MAY 29, 2025

Product News No.25 10E

Change in Salt Bath Nitriding Process Due to Environmental Compliance

< Reference > Solenoid Operated Directional Valves, DSG Series

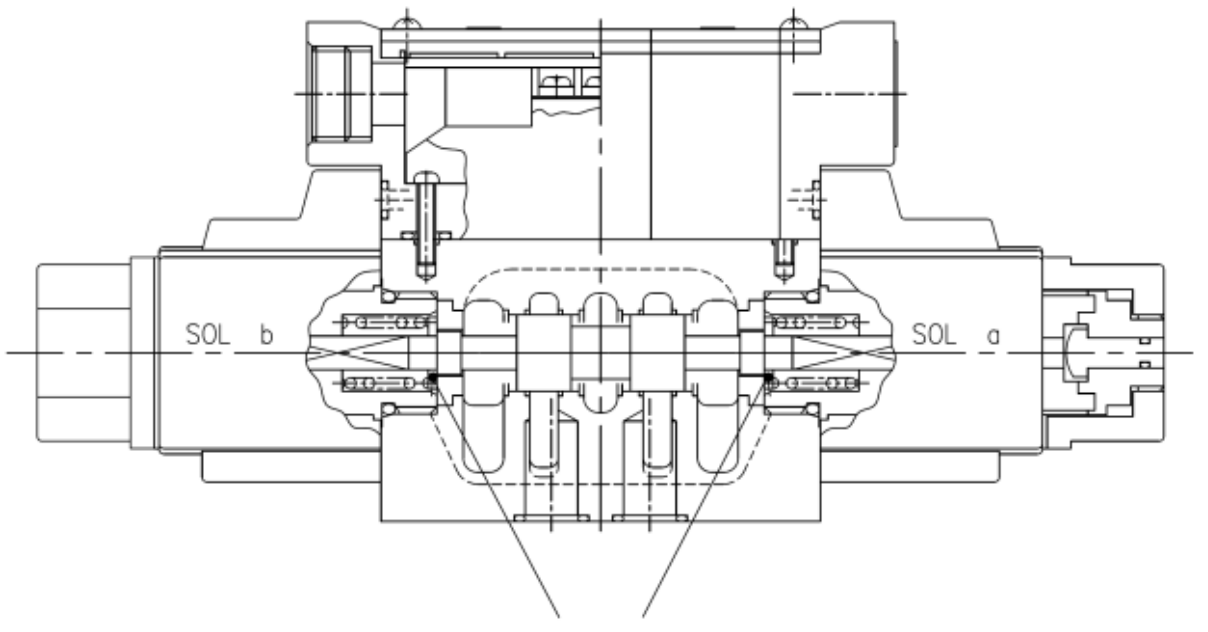
We will be switching to an environmentally friendly chemical agent for the salt bath nitriding treatment, which significantly reduces the use of cyanide compounds, substances known for their environmental impact.

Please note that, with the exception of certain products such as cartridge valves, the treated components are built into the internal parts of our hydraulic products and cannot be identified by external appearance.
